LEGAL NOTICE EXETER PLANNING BOARD AGENDA

Date: July 2, 2024
To: Planning Board
From: Dave Sharples, Town Planner
Re: Meniscus Financial Holdings LLC – 127 Portsmouth Avenue
PB Case #24-1

Re: Foss Motors – 127 Portsmouth Avenue – Commercial Site Plan
Response to Third Round of Underwood Engineers Comments

ELEVATIONS

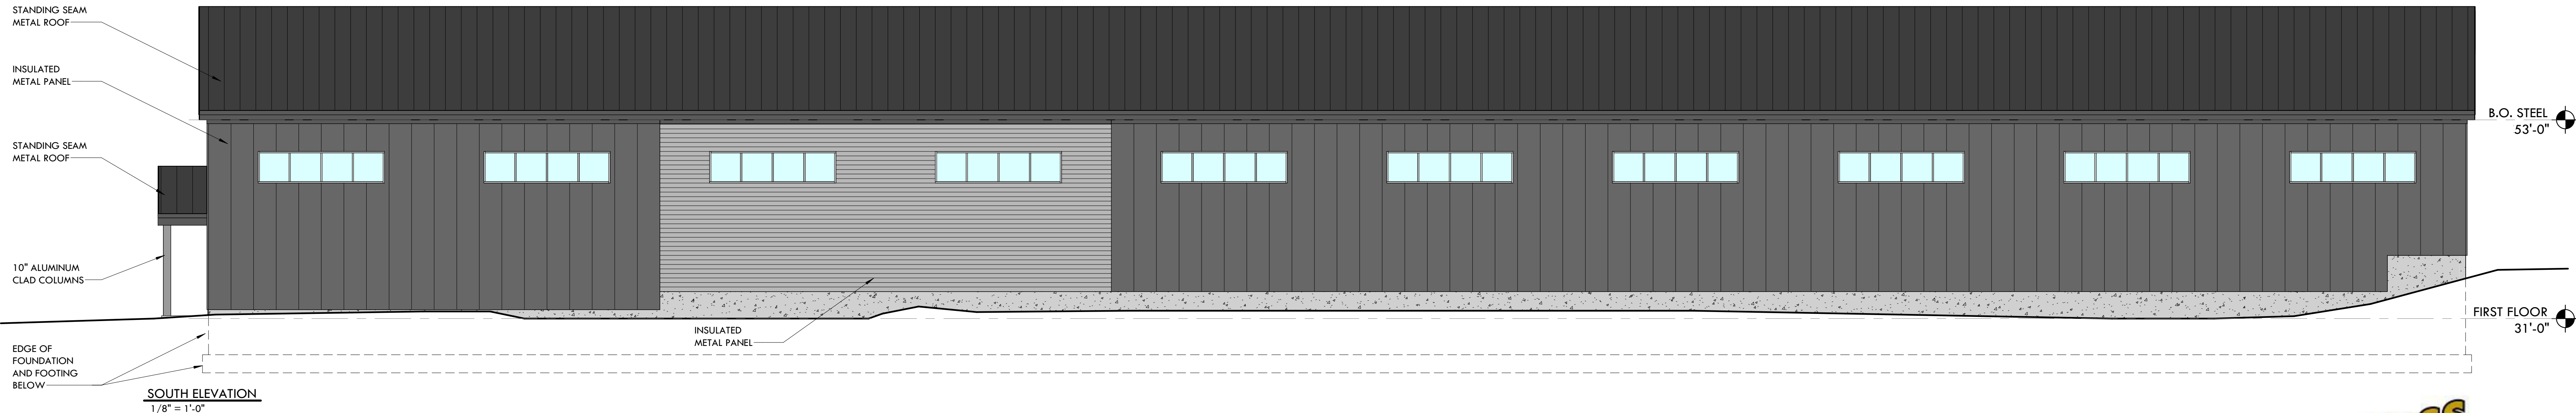
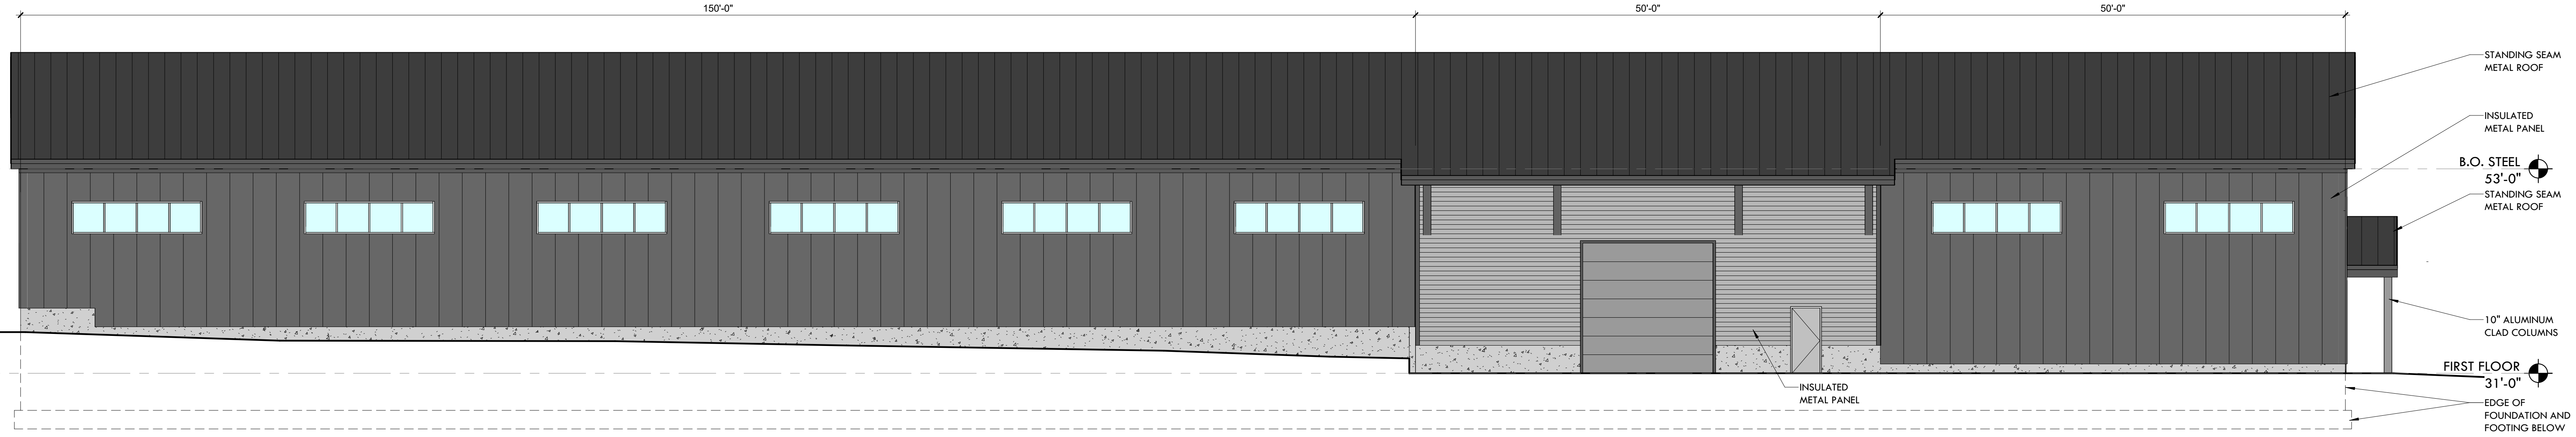
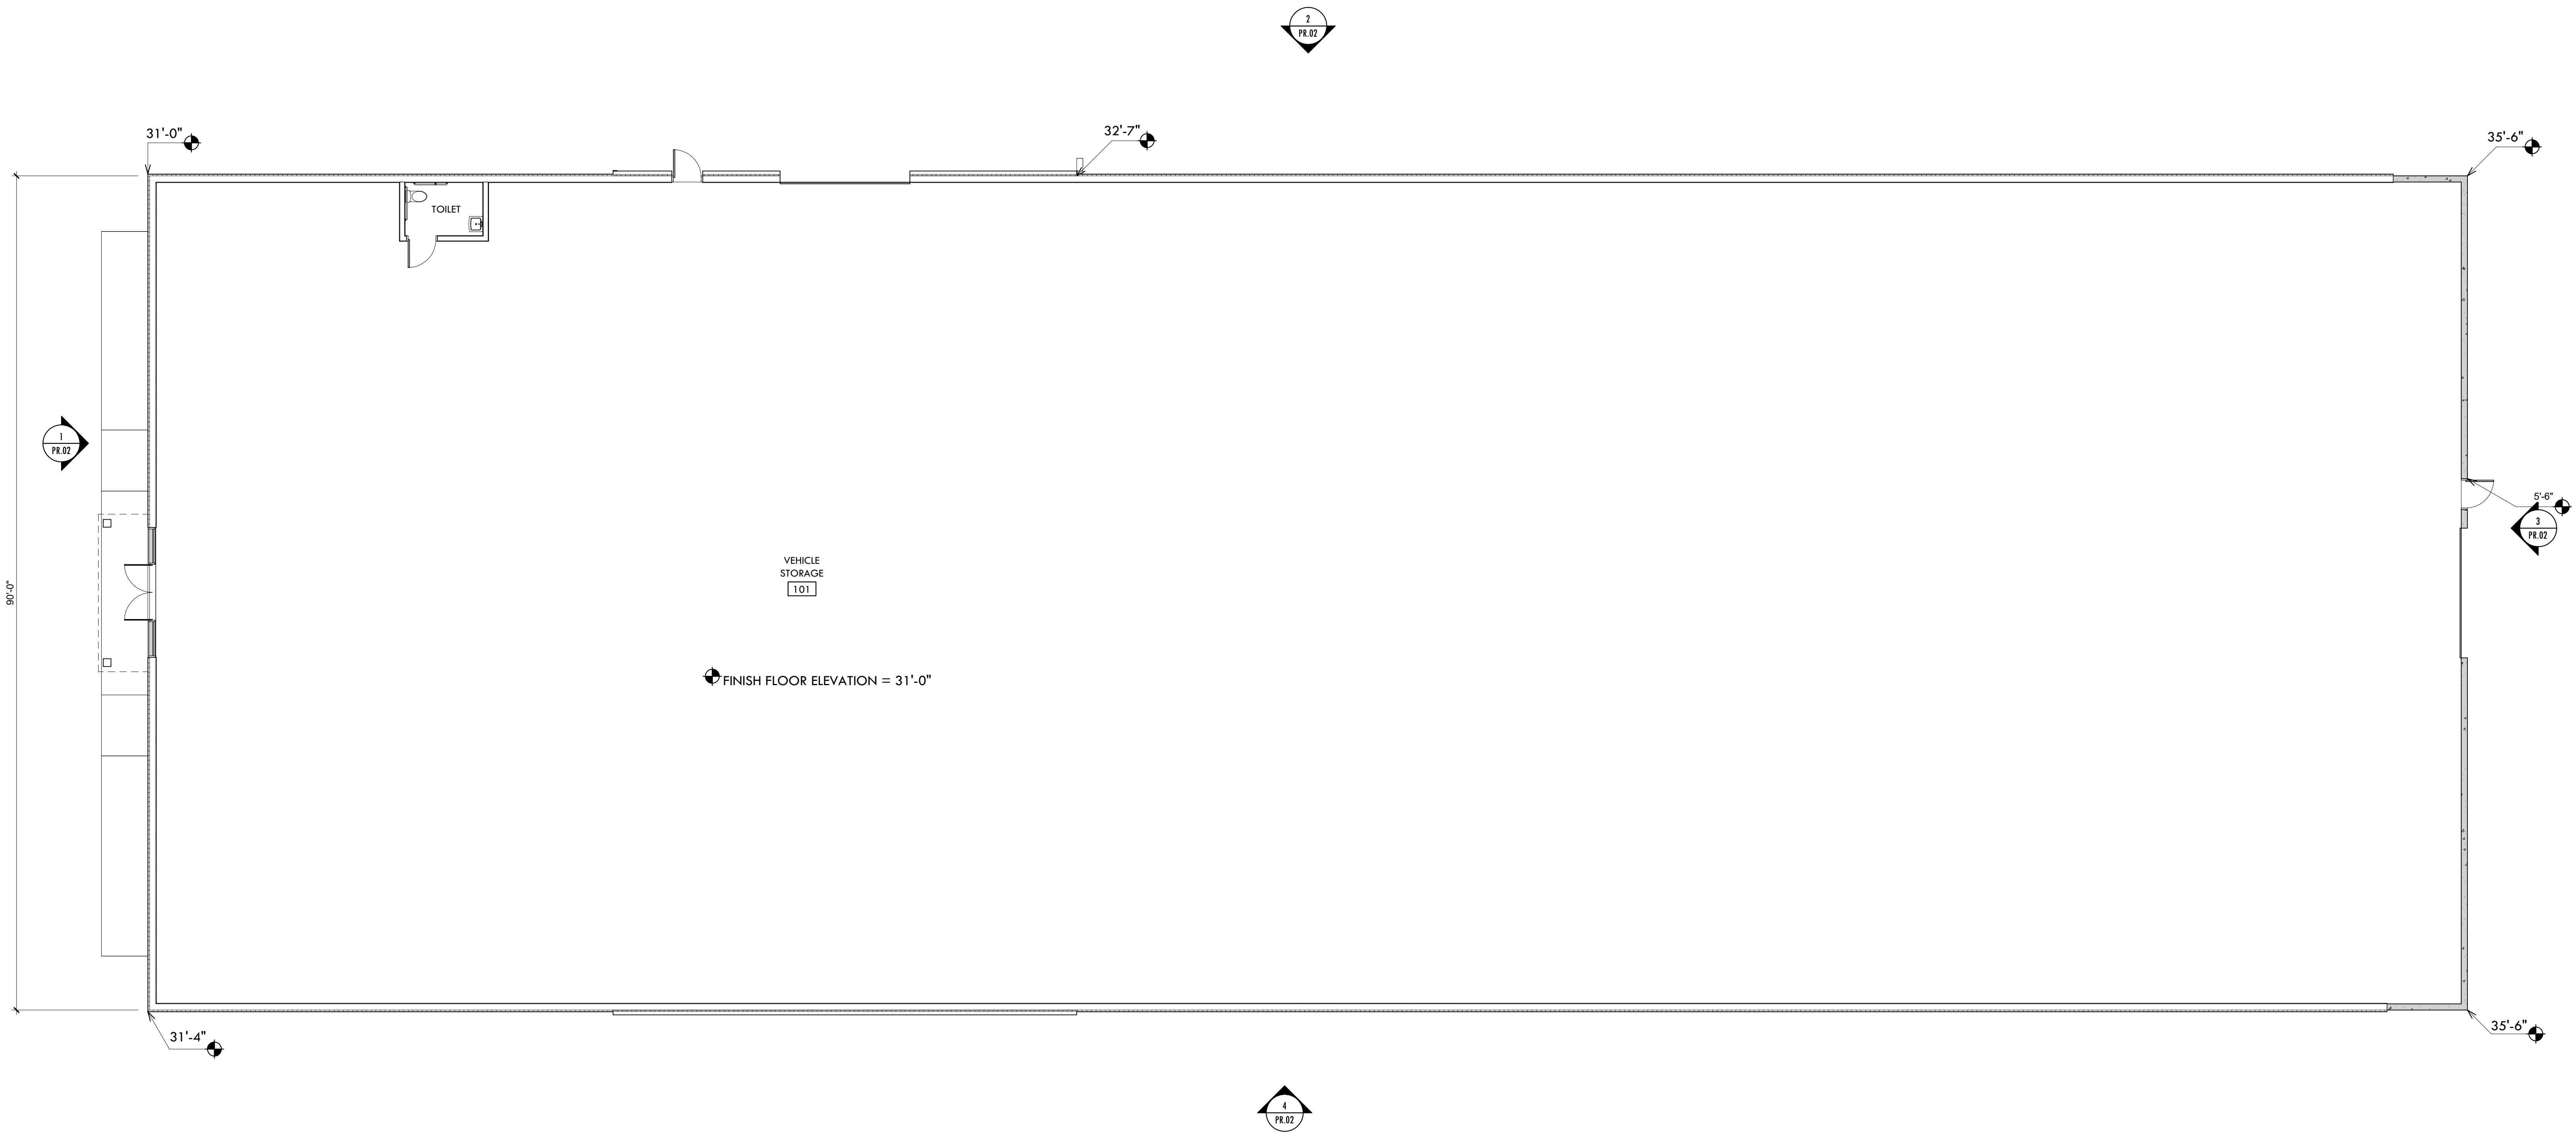
- 10.** It has been indicated that vehicles may be stored inside the building. No architectural plans have been received. It is unclear how and where the vehicles will be driven into the building.

Bears Latest Response: Elevations and a floor plan have been provided as part of this submission.
